**Model  
Administrative Change Notice**

| <b>1. Document Number:</b>      | MDL-NBS-HS-000010                   | <b>2. Revision:</b> | 03 | <b>3. ACN:</b> | 01 |
| <b>4. Title:</b>                | Site-Scale Saturated Zone Transport |                     |    |                |    |

Figure 6.7-9. Propagation of Input Uncertainty in the Flowing Interval Porosity in Volcanics to the Breakthrough Curves at the 18-km Boundary

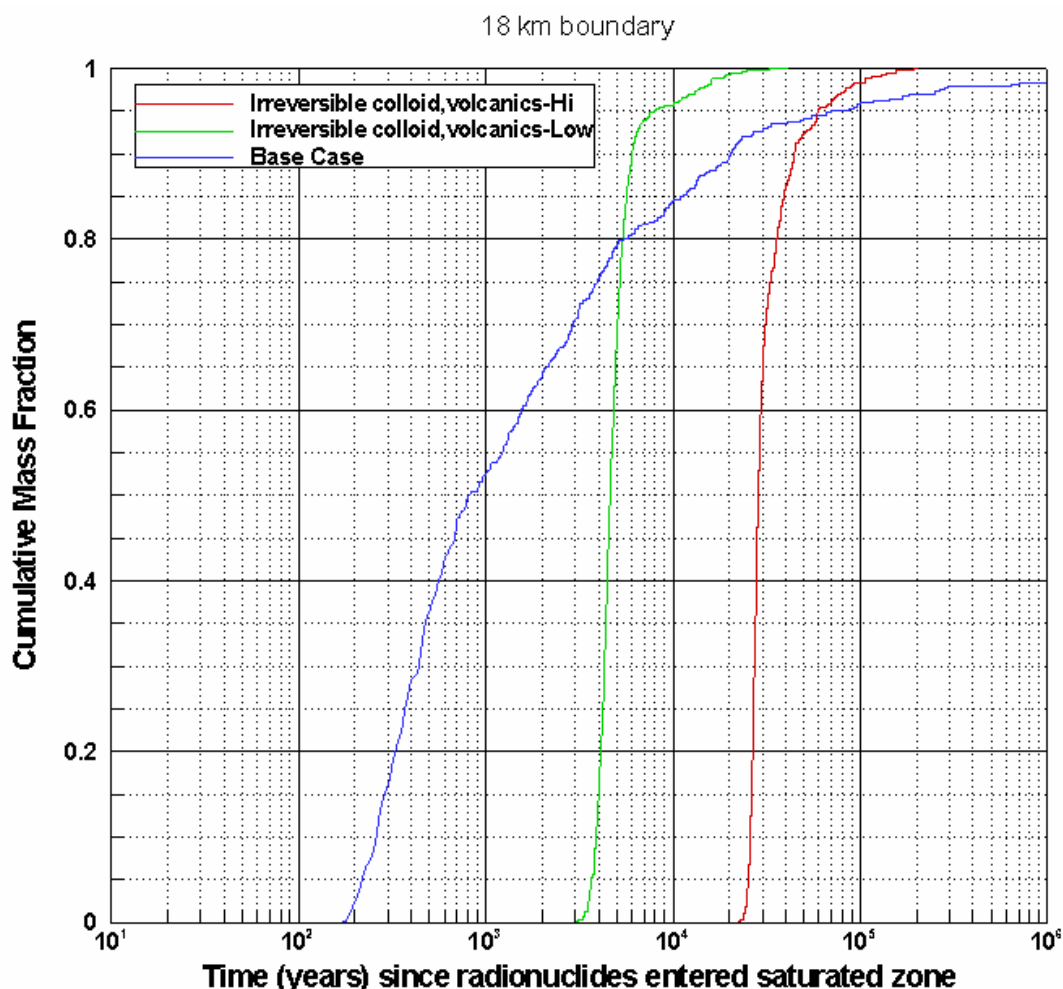
| 6-54                       | First paragraph, first sentence: Replaced “aperture” with “porosity”.<br>Second paragraph, first sentence: Added text to first sentence; changed callout from Figure 6.7-8 to Figure 6.7-9.  |                     |    |                |    |

The results from simulations that evaluate the effect of changes in flowing interval porosity in volcanics (holding flowing interval aperture fixed at the base-case value of  $25.773 \times 10^{-5}$  m) on the BTCs are shown in Figure 6.7-9.

Figure 7-9b. Transport Pathways Deduced from Hydrochemistry Data (in black, enlarged from Figure 7-9a) Overlaying Flow Paths Calculated from the Site-Scale Saturated Zone Transport Model (in blue) for Tracer Particles Starting at the Repository Footprint

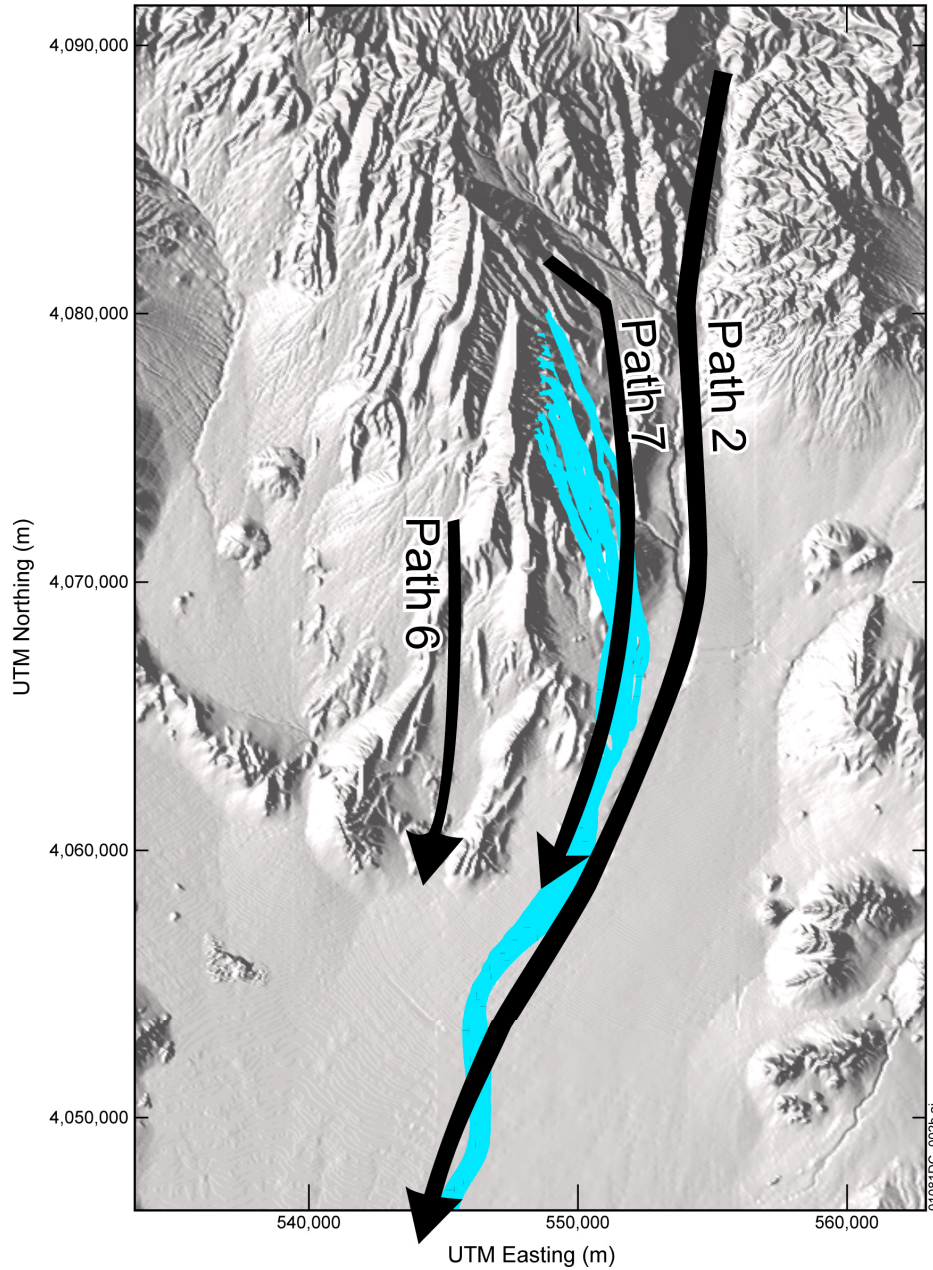
| 7-26                       | Replaced Figure 7-9b. The path lines were labeled, and were shifted slightly to the east to be consistent with the Figure 7-9a. The visual validation is not affected by the shift. Also, the figure caption was corrected to correspond to the different coloring of the new path lines, and now reads “Transport Pathways Deduced from Hydrochemistry Data (in black, enlarged from Figure 7-9a) Overlaying Flow Paths Calculated from the Site-Scale Saturated Zone Transport Model (in blue) for Tracer Particles Starting at the Repository Footprint”. |                     |    |                |    |

Figure G-5. Surface Area, Combined Smectite and Clinoptilolite, and K<sub>d</sub> Values for Np(V)

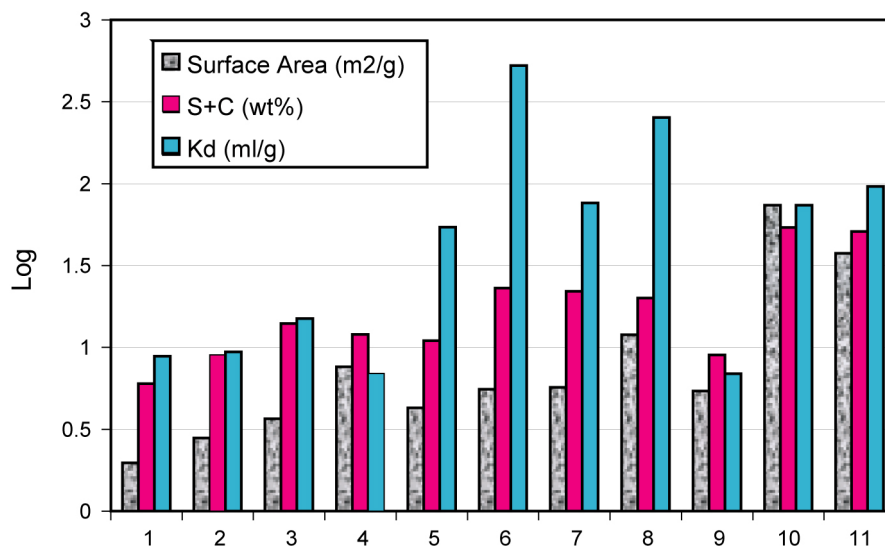
| G-10   | Figure G-5, source line: Removed DIRS 180904.  |                     |    |                |    |
